City of Mississauga Department Comments

Date Finalized: 2023-06-14 File(s): A154.23

The applicant requests the Committee to approve a minor variance to allow the construction of an accessory structure proposing:

Property Address: 2200 Robinwood Crt

Appendix 1 – Transportation and Works Comments

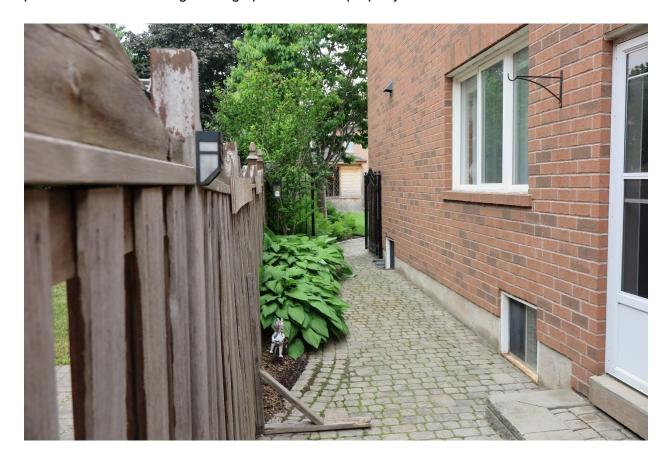
We are noting for Committee's information that any Transportation and Works Department concerns/requirements for the proposed accessory structure will be addressed through the Building Permit Process. Acknowledging that we were not able to access the rear yard on our site inspection, we note that we do not foresee any drainage related concerns with the proposal provided that the existing drainage pattern on the property be maintained.
